**ADDENDUM NO. 01**

February 4, 2010

Project: **Dickinson High School Additions and Renovations**  
Dickinson Independent School District

Bay Project No.: **0743**

# PARTIAL REVISED PLAN 1/A0.01

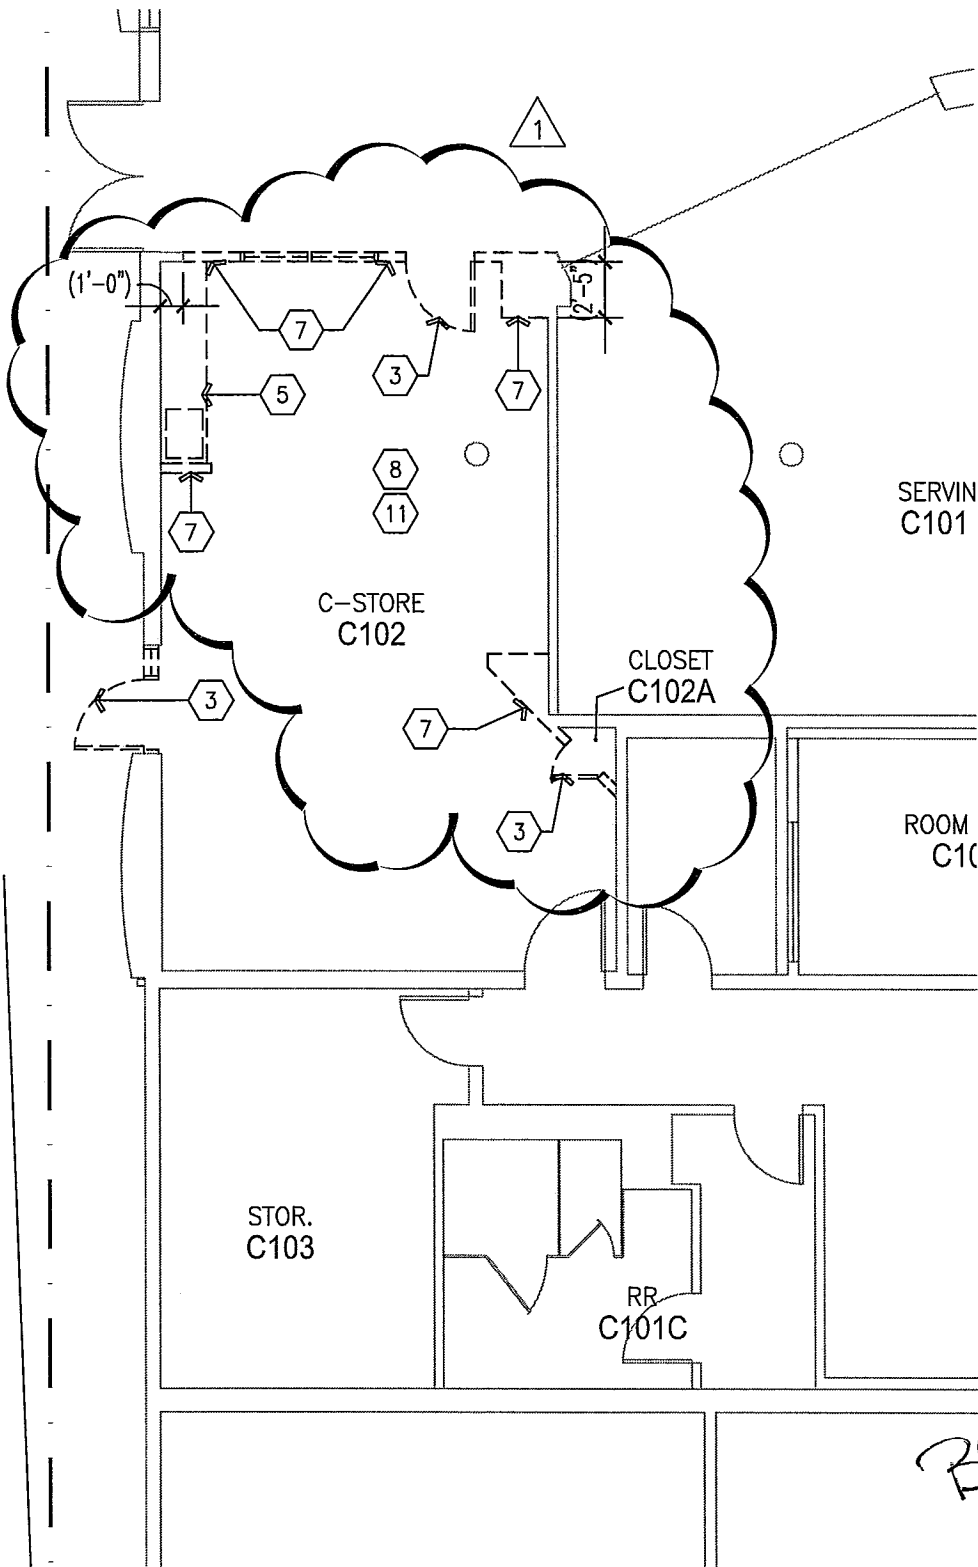
06.     Sheet A0.01 - First Floor Demolition Plan Unit "C": Change demolition note #1 to note #7 see attached **ADD-01-01** and **ADD-01-02** sketches.

# PARTIAL REVISED PLAN 2/A0.01

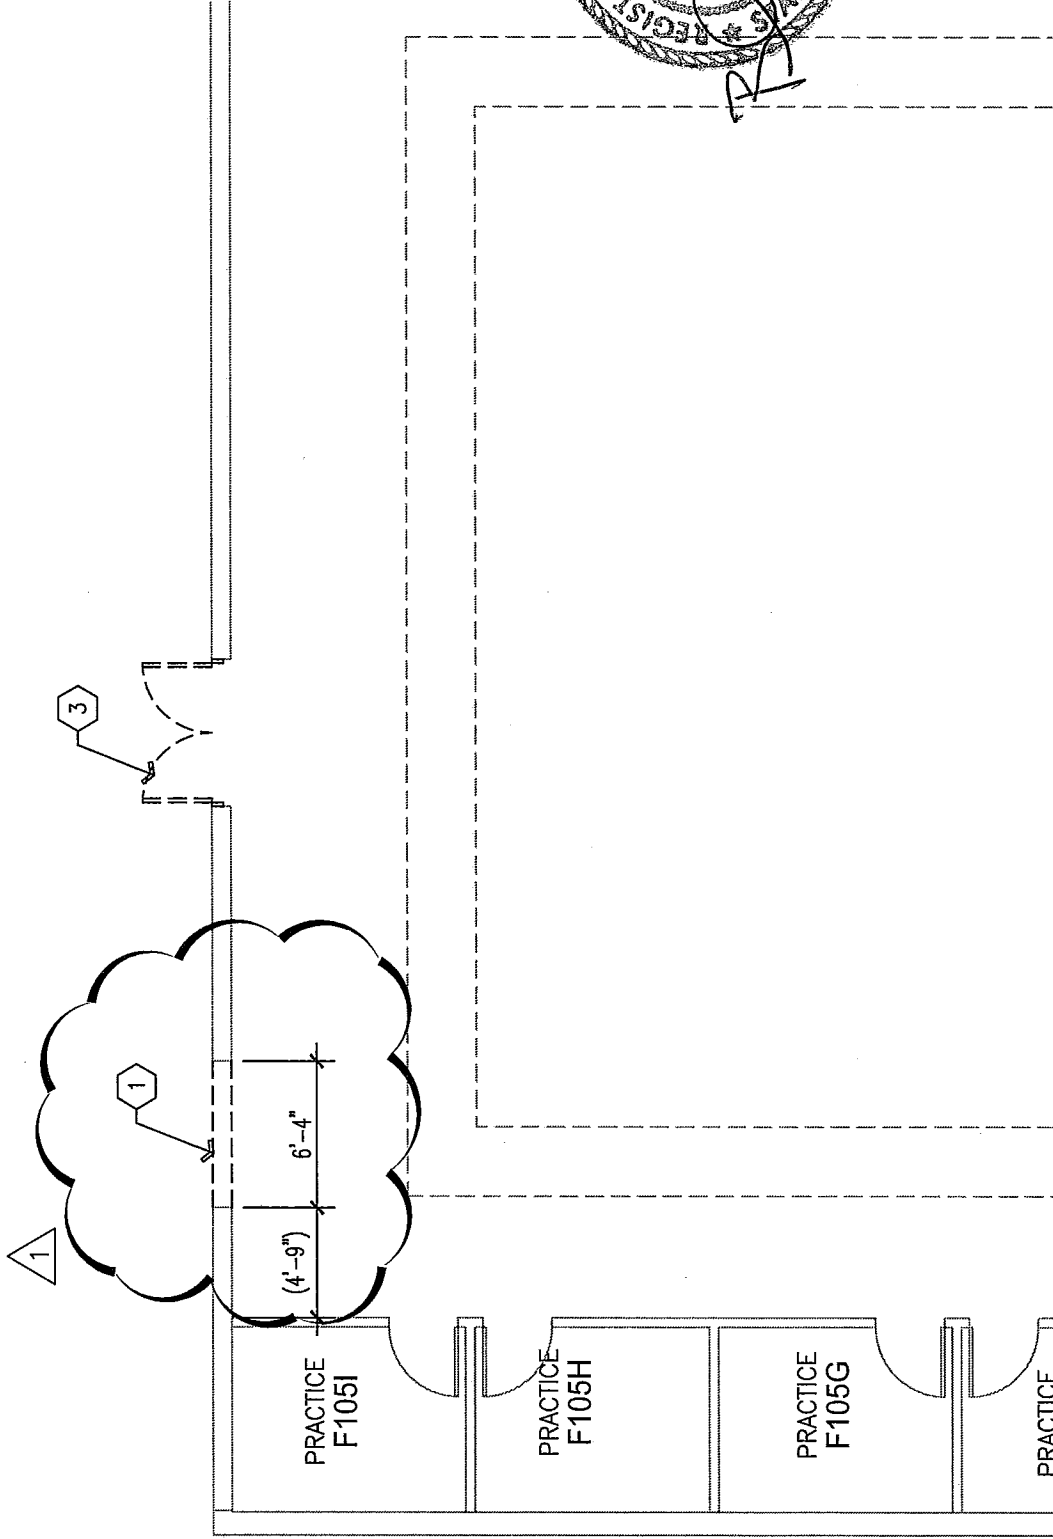
07.     Sheet A0.01- Demolition Plan at Exist. Band: Add demolition note #1 see attached **ADD-01-03** sketch.
08.     Sheet A2.16 – Second Floor Unit N Area "E": Prep Room N213, change partition type to D24. See attached **ADD-01-04** sketch.

## PARTIAL REVISED PLAN 1/A2.24

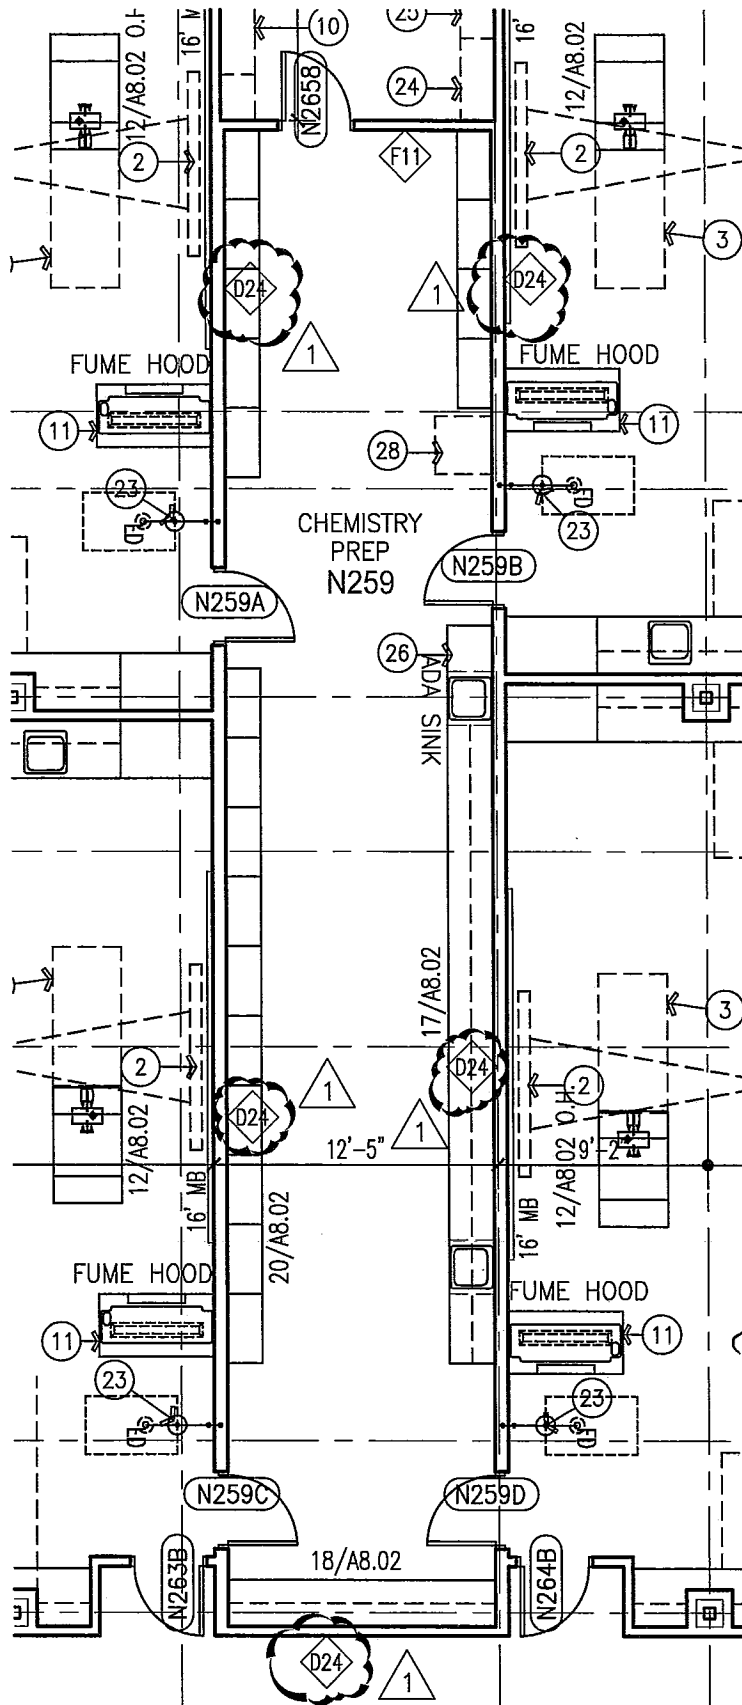
09.     Sheet A2.24 – Second Floor Unit N Area "G": Chemistry Prep Room N259 change partition type to D24. See attached **ADD-01-05** sketch.
10.     Sheet A2.25- Unit "C" Schedules: Remove C113 from the door and finish schedules.

# PARTIAL ELEVATION 9/A7.03

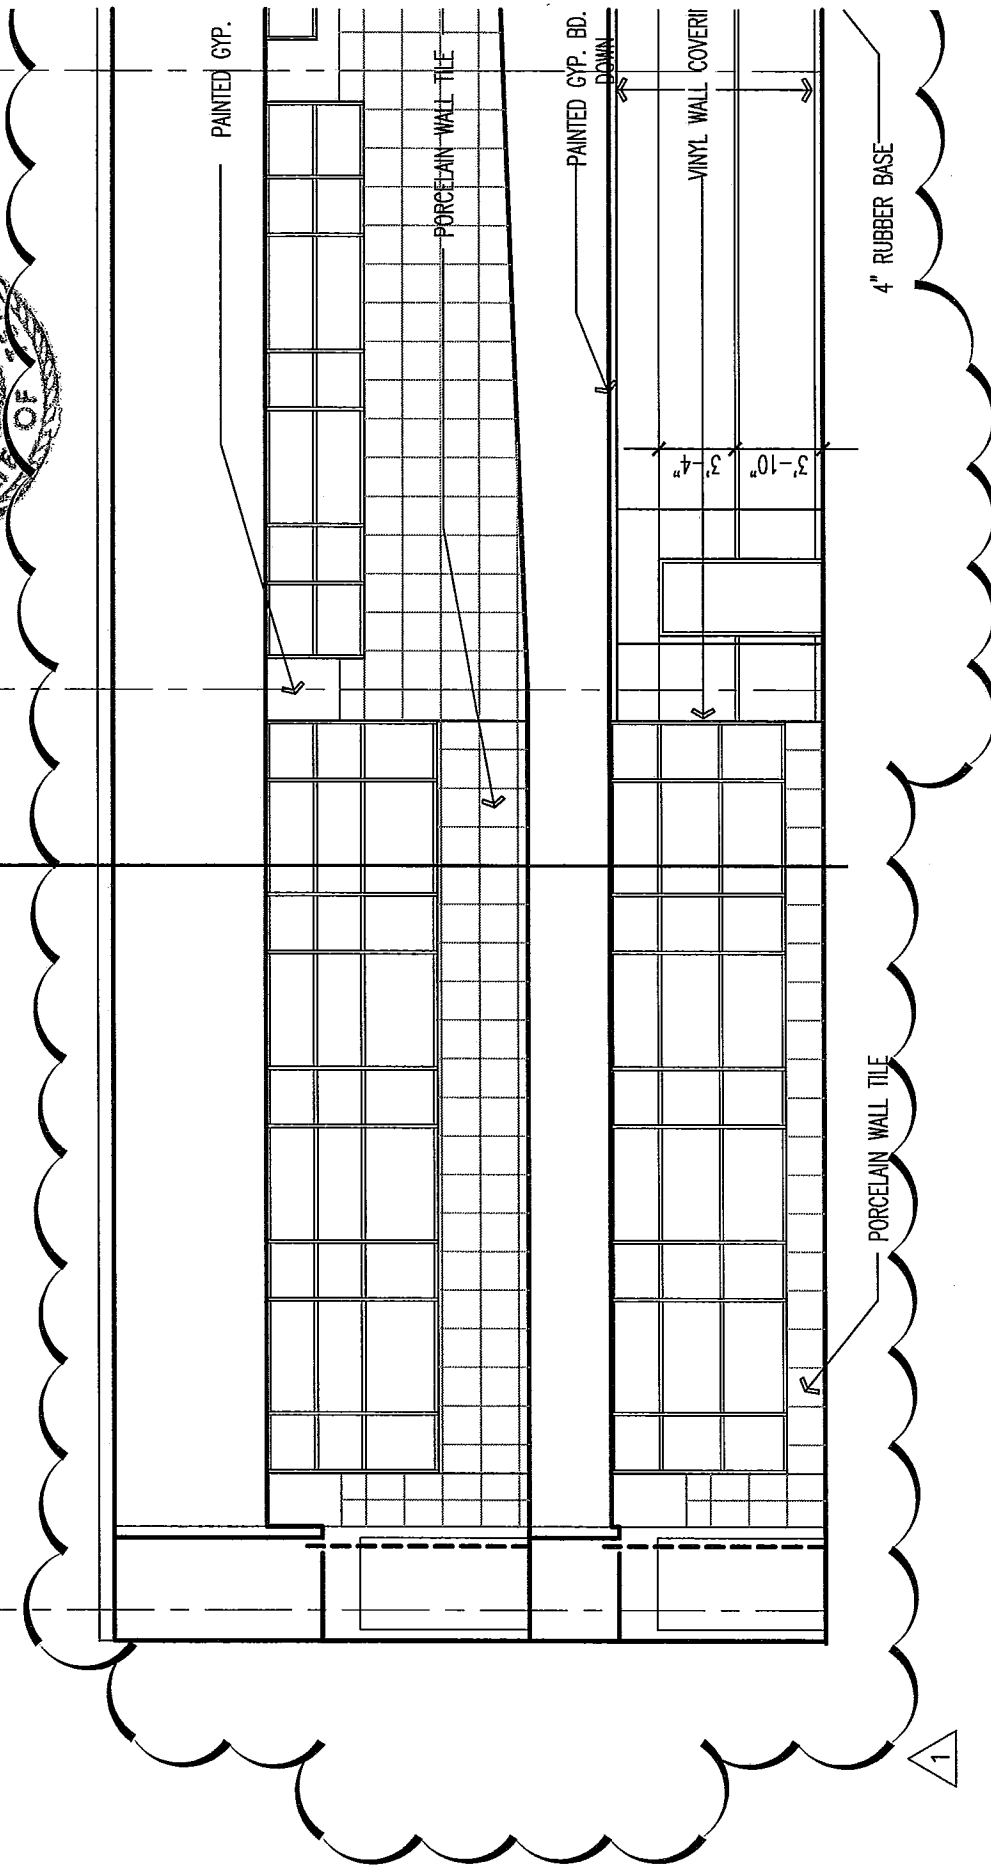
20.     Sheet A7.03 – Exterior Elevations: Replace detail 9/A7.03 with attached **ADD-01-07** and **ADD-01-08** sketches.
21.     Sheet A7.05 – Interior Elevations: Detail 12 shows the relocation of the return air louvers in the gym. See attached **ADD-01-09** and **ADD-01-10** sketches.

# PARTIAL PLAN 1/A10.02

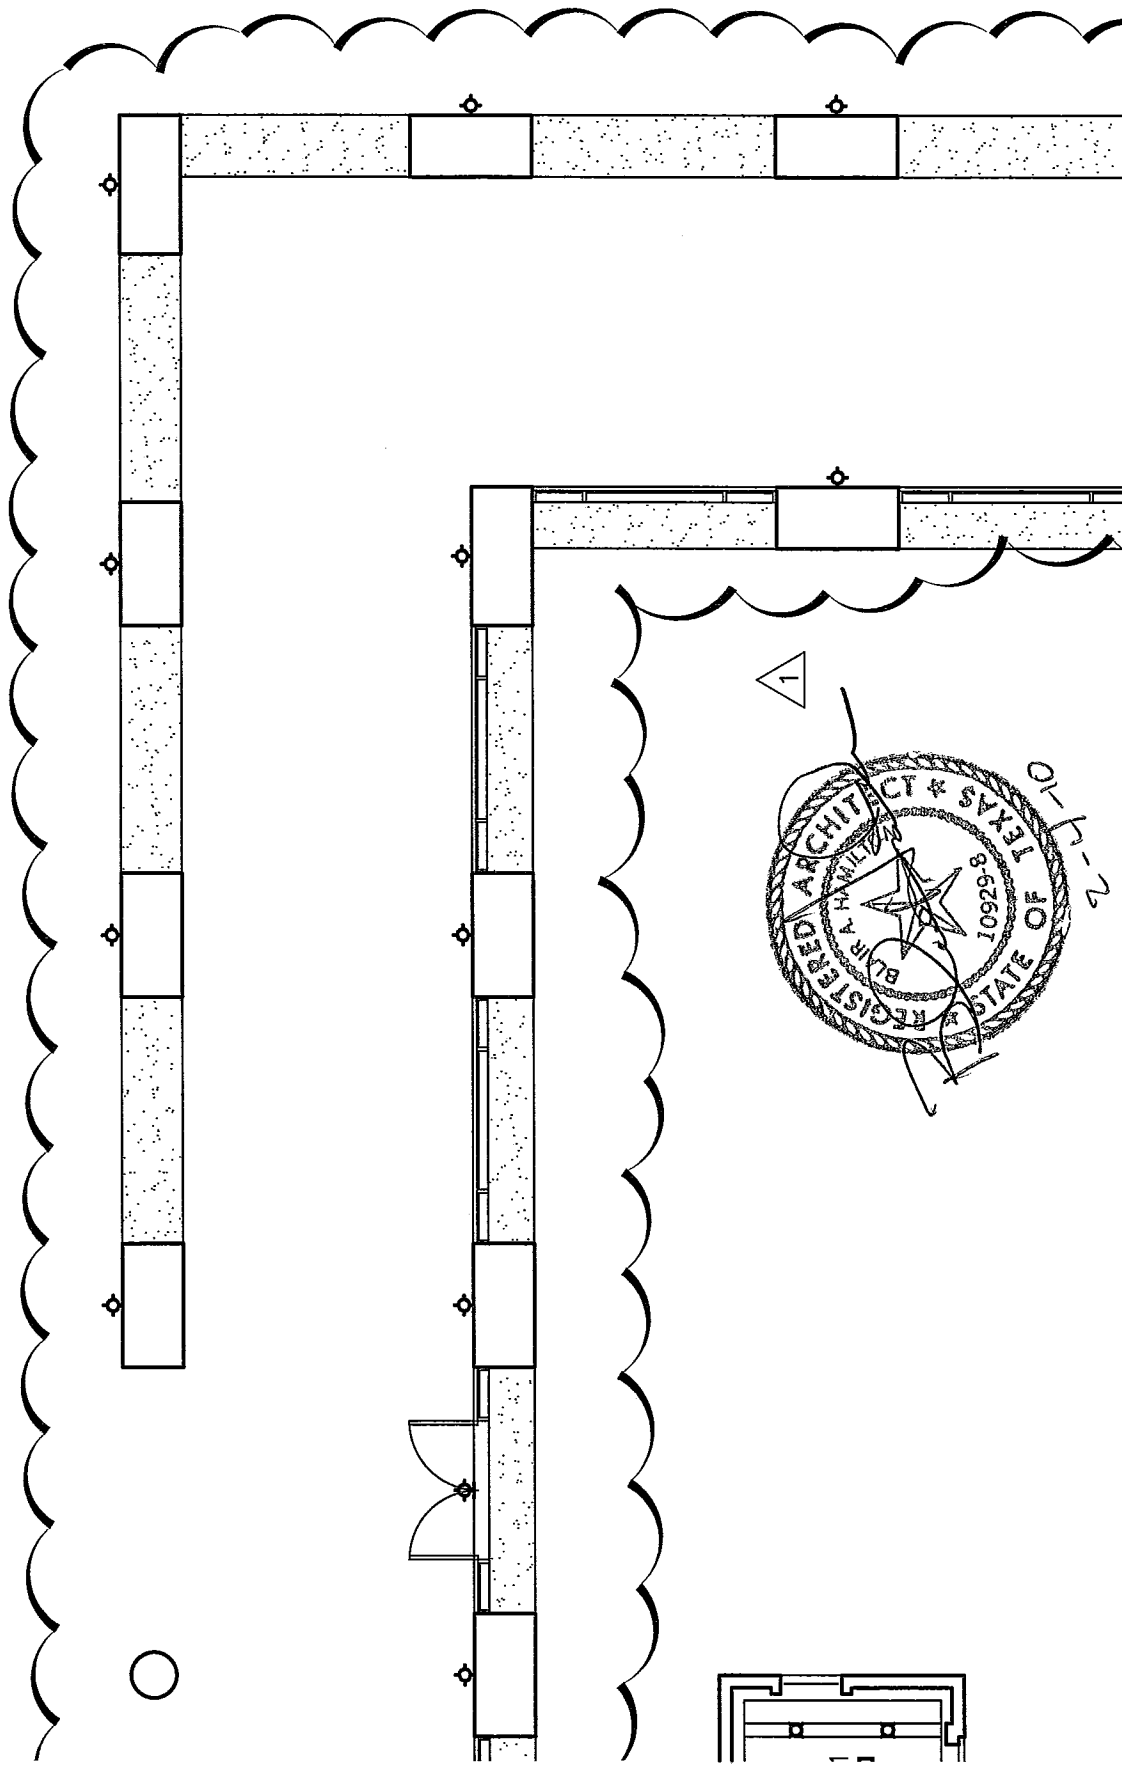
22. Sheet A10.02 Unit "N" Area "A" – First Floor Reflected Ceiling Plan: Revise lighting. See attached **ADD-01-11** and **ADD-01-12** sketches.
23. Sheet A10.10 - Unit N Area "D" Reflected Ceiling Plan: At Corridor N001 remove six lights at the corridor intersections. See attached **ADD-01-13** sketch.
24. Sheet A10.12 - Unit N Area "D" Second Floor Reflected Ceiling Plan: At Corridor N200 remove six lights at the corridor intersections. See attached **ADD-01-14** sketch.
25. Sheet A10.22 - Unit N Area "G" First Floor Reflected Ceiling Plan: At Corridor N100 remove four lights at the corridor intersections. See attached **ADD-01-15** sketch.
26. Sheet A10.24 - Unit N Area "G" Second Floor Reflected Ceiling Plan: At Corridor N248 remove four lights at the corridor intersections. See attached **ADD-01-16** sketch.
